VILLAGE OF DOWNERS GROVE
 Report to the Village
 3/6/2018

SUBJECT:	SUBMITTED BY:
2001 63rd Street - Planned Unit Development Amendment, Special Use and Plat of Subdivision	Stan Popovich, AICP Director of Community Development

SUBJECT:	TYPE:	SUBMITTED BY:
17-PLC-0041 2001 63 rd Street	PUD Amendment, Special Use and Plat of Subdivision	Rebecca Leitschuh, AICP Senior Planner

EAST ELEVATION

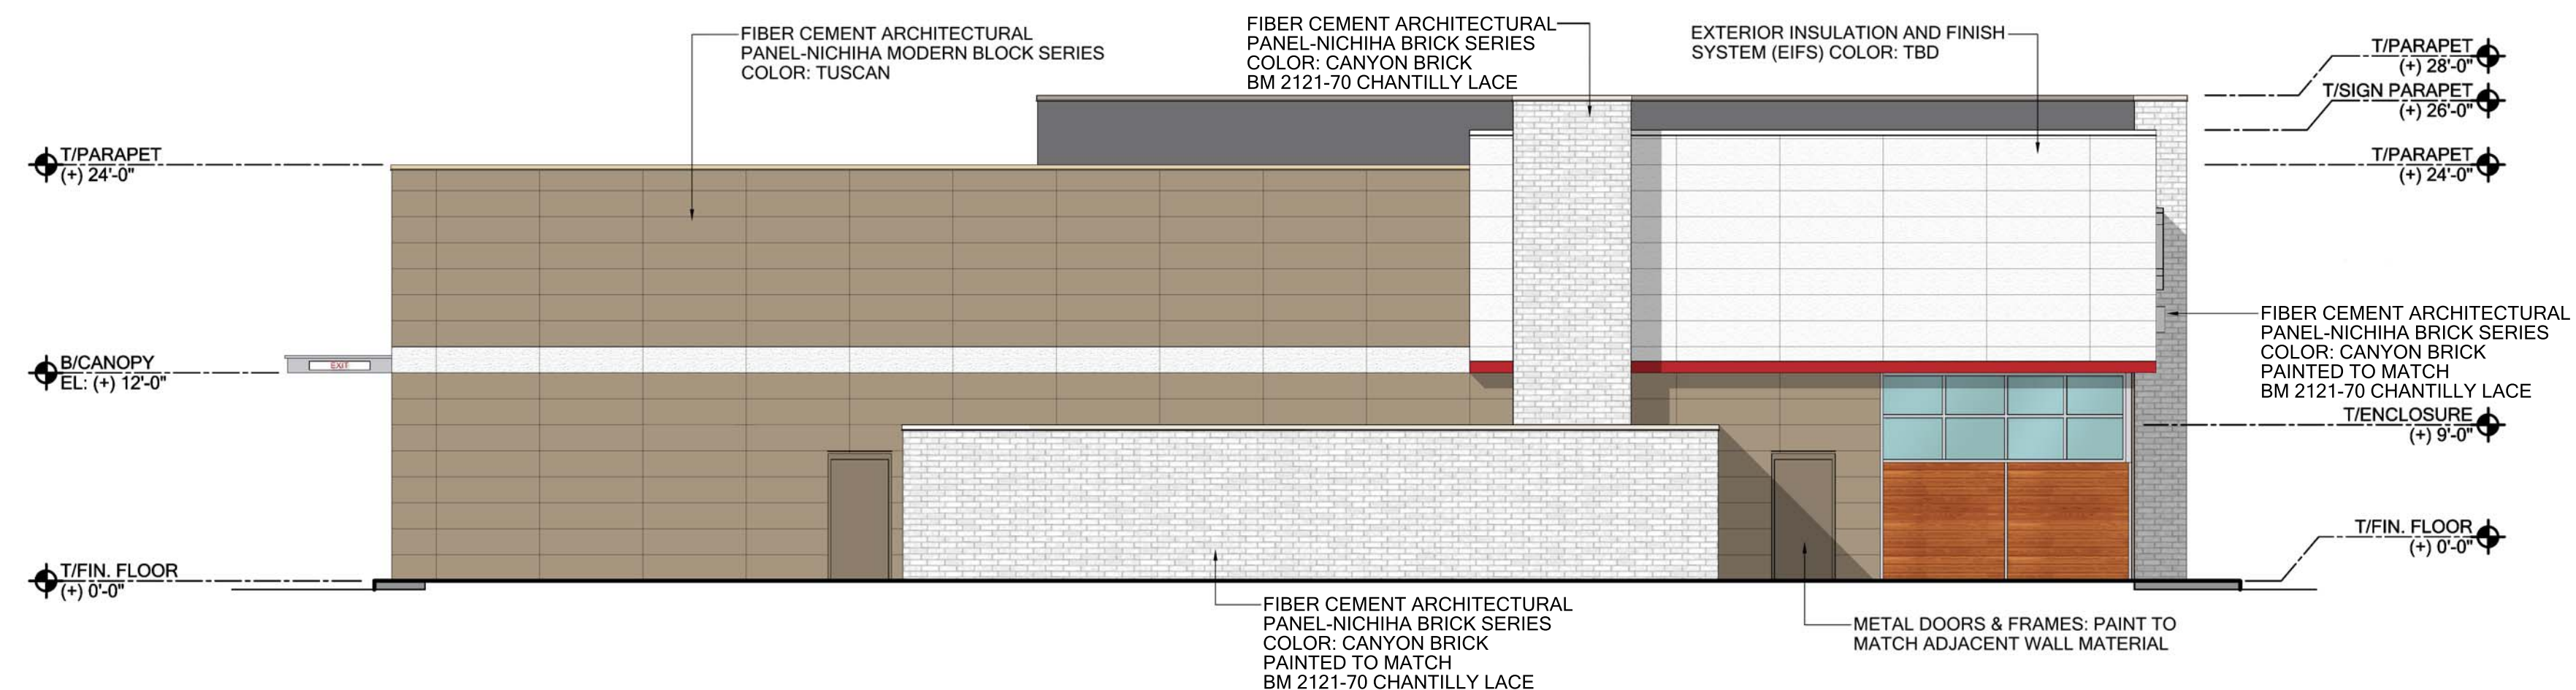
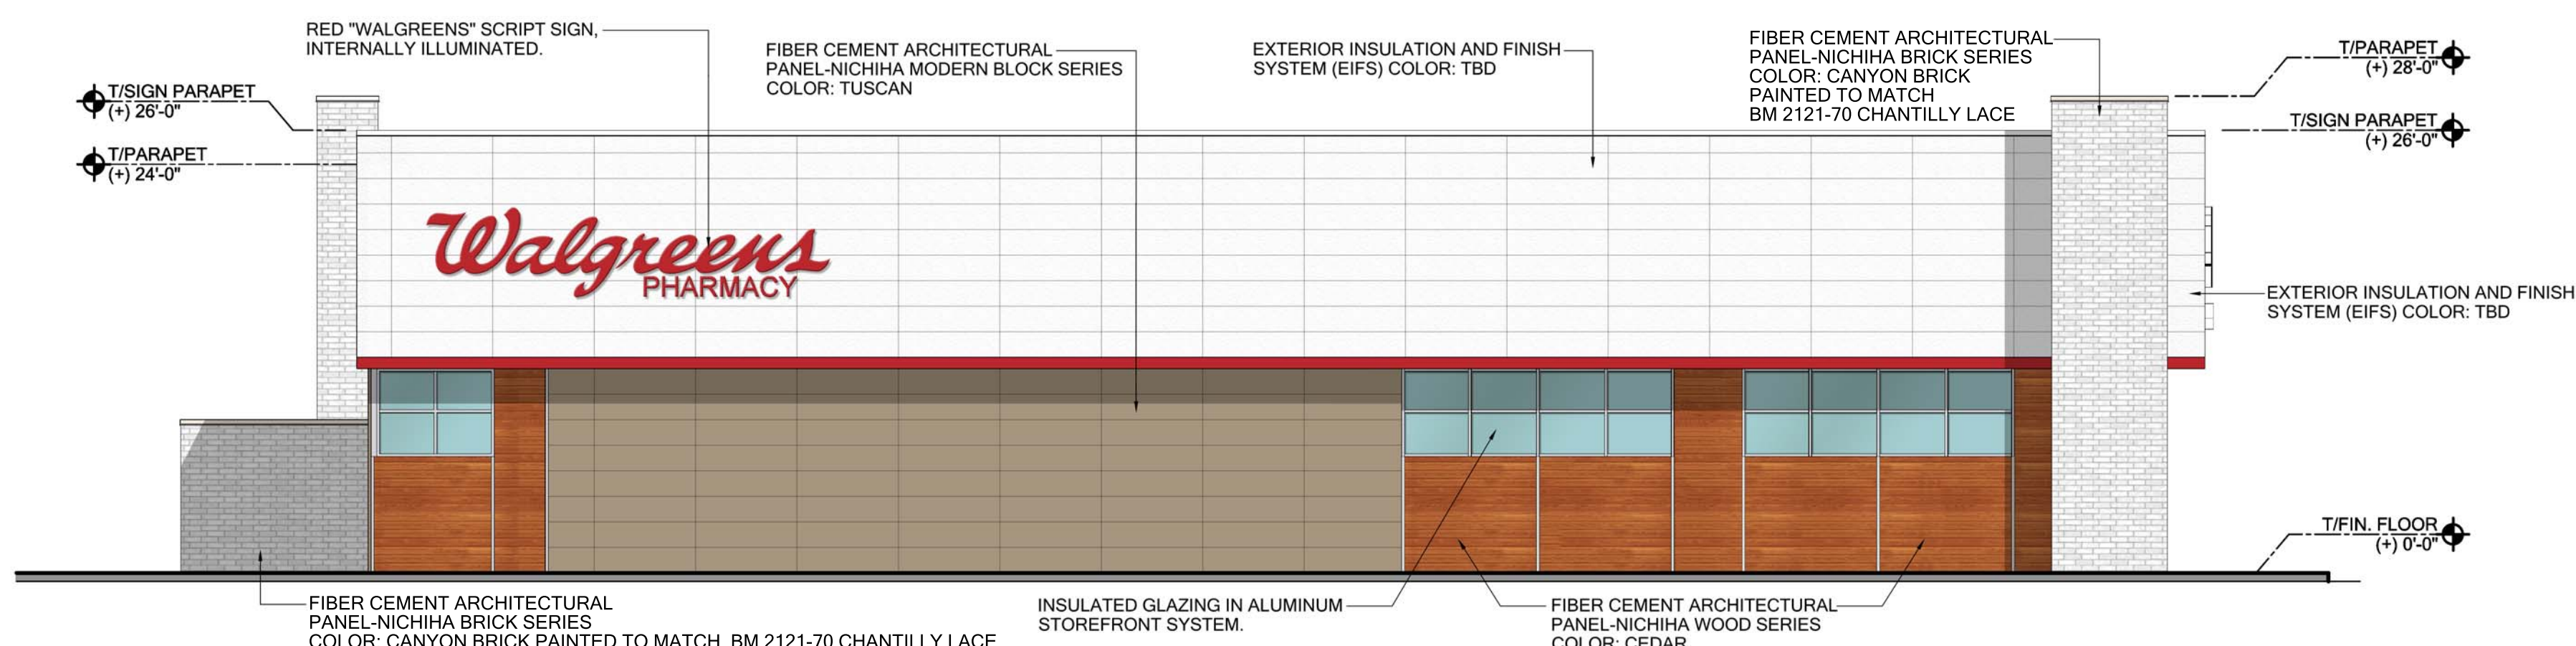
The Woodward Avenue (east) elevation continues to wrap the corner with wood panels, windows, and the white EIFS overhang. Staff requests a condition be made to extend the EIFS design element across the entire length of the eastern wall so as to bring greater design detail to the east elevation. A vertical pier, identical to the one on the western elevation, intersects the horizontal planes. The dumpster enclosure, while in a street yard, is designed to complement the building, incorporating the same fiber cement panel system.

Revised east elevation

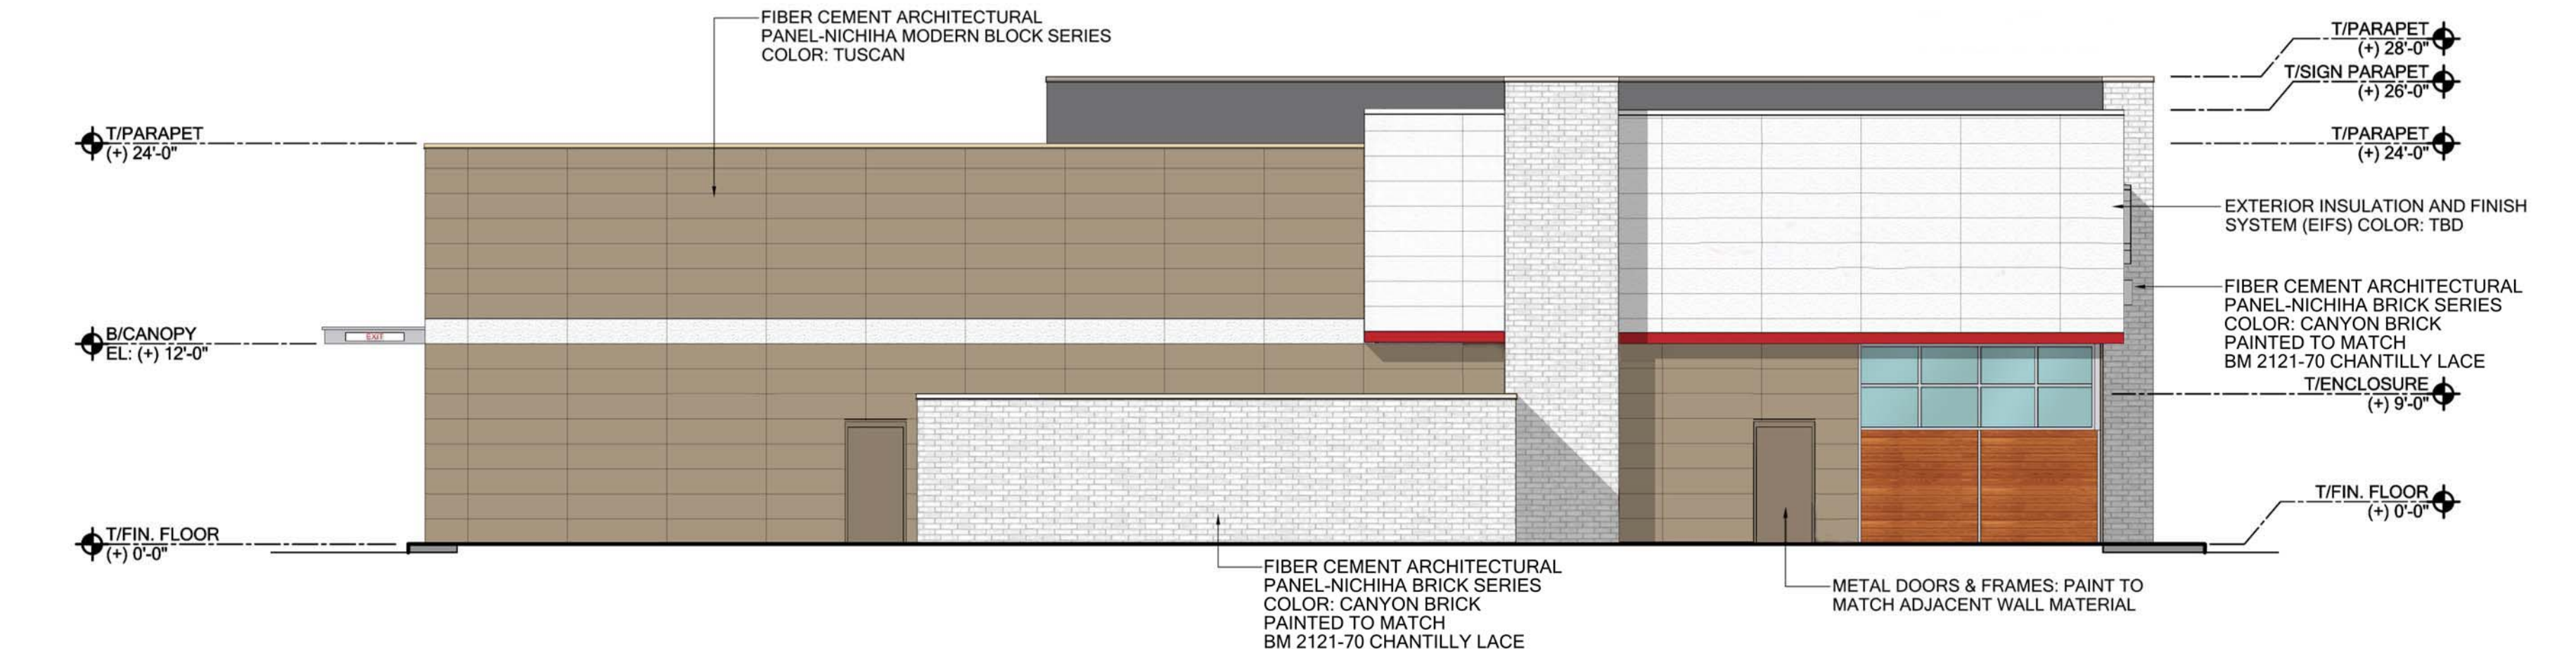
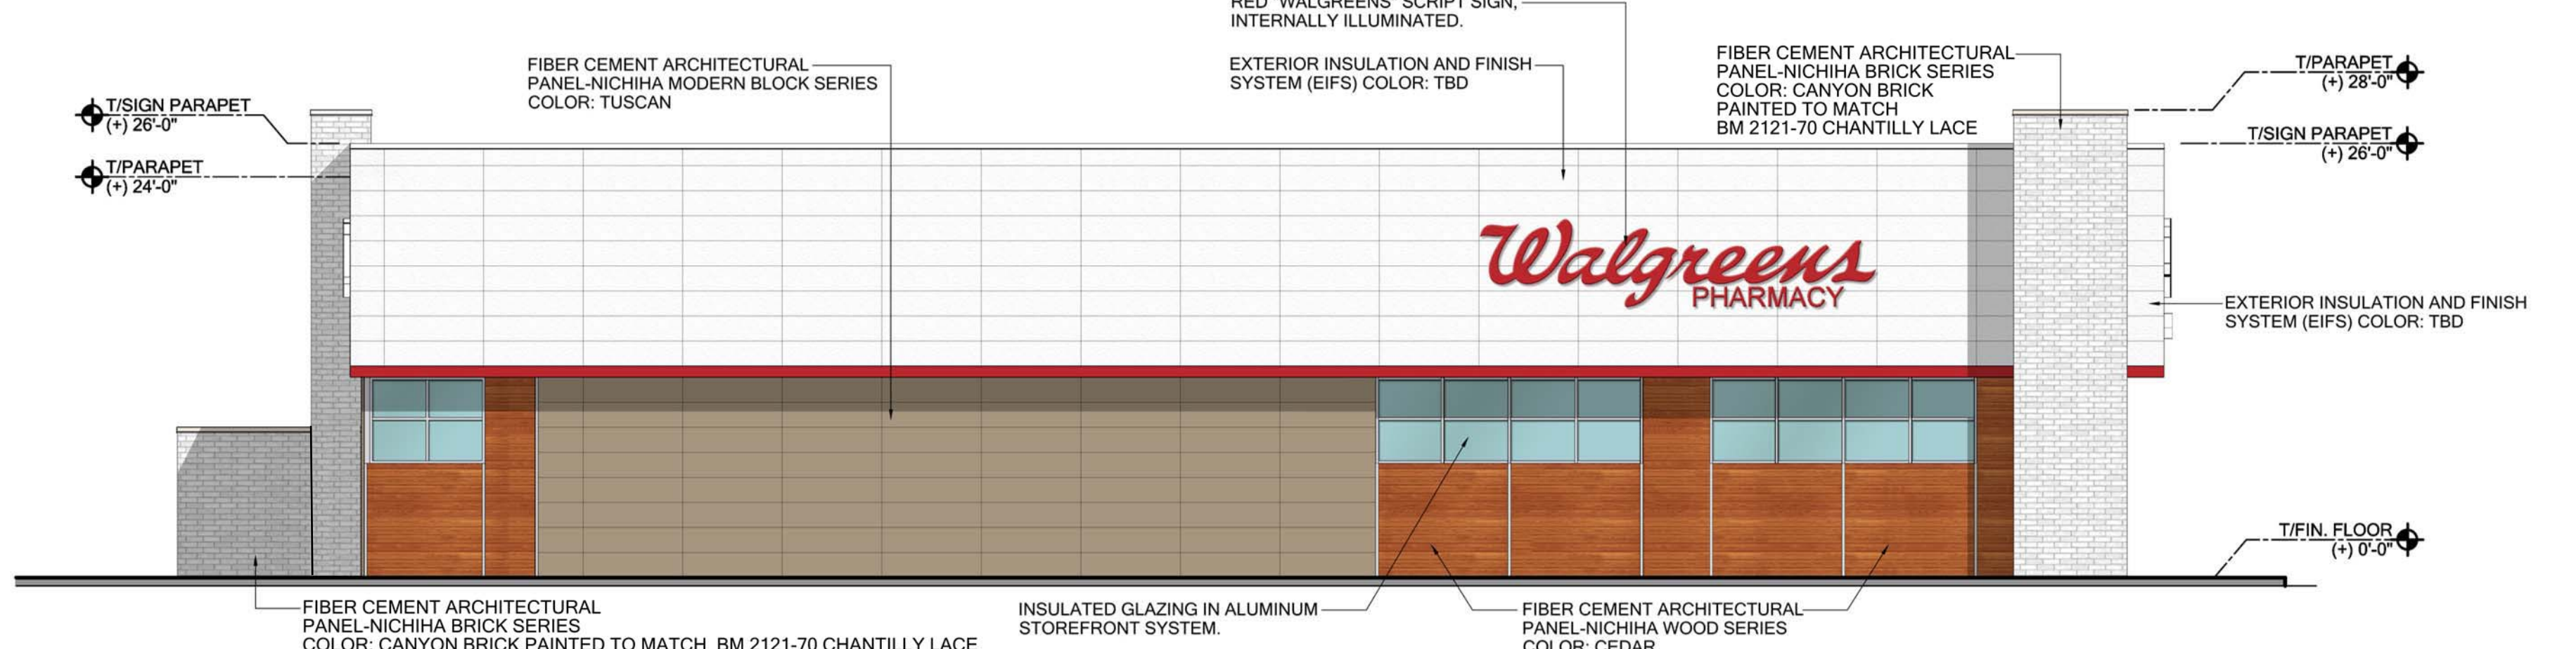
This item was discussed at the February 20, 2018 Village Council meeting. Based on Council direction, the petitioner has revised the east elevation so the left side of the elevation mimics the right side of the elevation. The new windows on the left side of the elevation will be opaque spandrel glass. The spandrel glass will appear as a window; however, you will not be able to see through the spandrel glass. The revised elevations are attached.
